# Work Order ID 91933

Item Name: Energy Attenuating Floor Provisions

# DART SERVICE INSTRUCTION

TO AMEND INSTALLATION INSTRUCTIONS IIN-D350-689 REV. B  
AND INSTRUCTIONS FOR CONTINUED AIRWORTHINESS ICA-D350-689 REV. 1  
REF. TCCA STC: SH02-33  
REF. FAA STC: SR01620NY  
REF. EASA STC: EASA.IM.R.S.01453  
REF. TCA STC: 2005S03-09

**FIGURE 1: UPDATES TO FIGURE 21 (IIN-D350-689) AND 25-21 (ICA-D350-689)**

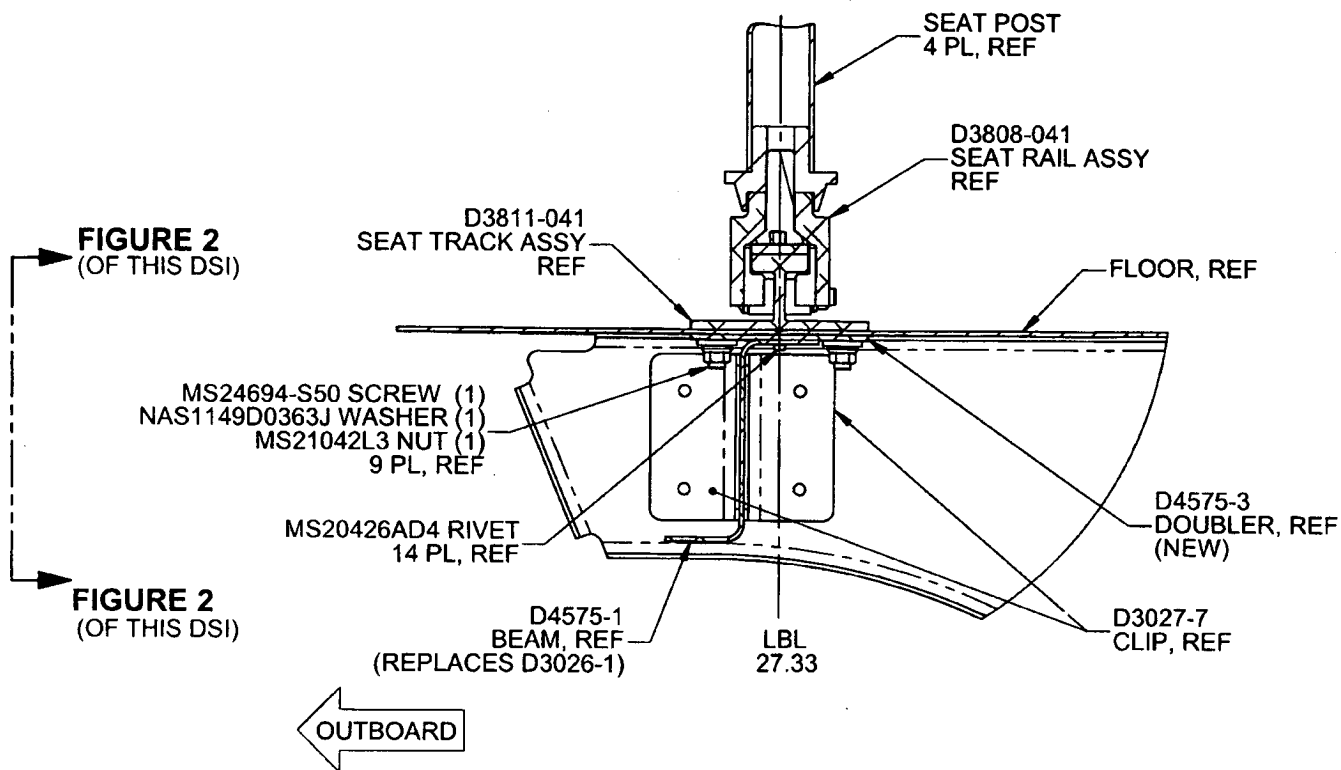
If there is an existing stringer at LBL 27.33, it will need to be removed from that location. Locate D4575-1 Beam and D4575-3 Doubler as shown in Figure 1 of this Service Instruction. Transfer drill existing holes from the aircraft floor to the D4575-1 Beam and D4575-3 Doubler. Ensure 1.0" to 1.5" rivet pitch and add additional holes if required. If there is no existing stringer, locate D4575-1 Beam and D4575-3 Doubler as shown in Figure 1 of this Service Instruction and drill Ø0.128" holes on a 1.0" to 1.5" pitch.

If there is an existing stringer at LBL 27.33, it will need to be removed from that location. Locate D3026-1 Channel as shown in Figure 4 and transfer existing holes from the aircraft floor to the D3026-1 Channel. Ensure 1.0" to 1.5" rivet pitch and add additional holes if required. If there is no existing stringer, locate D3026-1 Channel as shown in Figure 4 and drill Ø0.128" holes on a 1.0" to 1.5" pitch.

**FIGURE 2: RELIEFS ON D4575-1/-3**  
(ONLY D4575-1/-3 SHOWN FOR CLARITY)  
VIEW LOOKING INBOARD

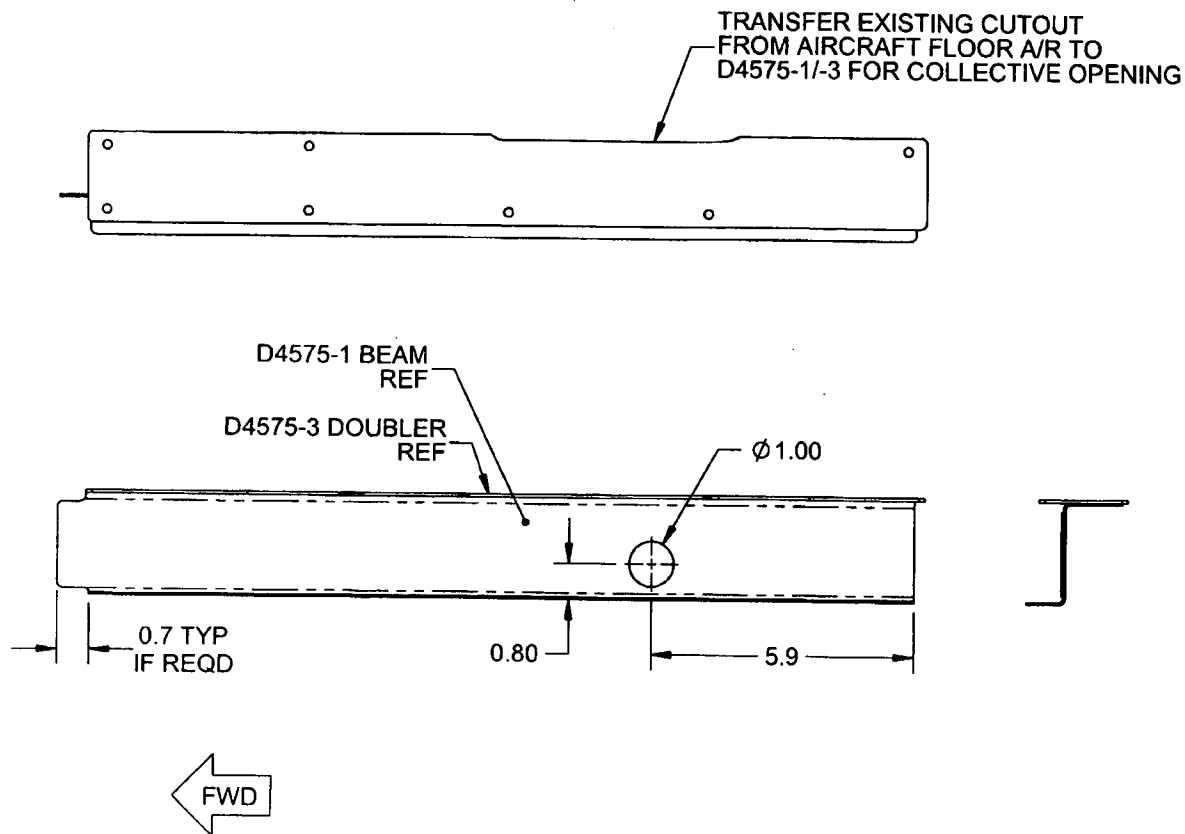
**Note:** Drill a Ø1.00" (Ø25.4 mm) hole in the D4575-1 Beam to clear extension tube of collective and cutout as required for clearance of collective opening and fwd bulkhead as shown in Figure 2 of this Service Instruction.
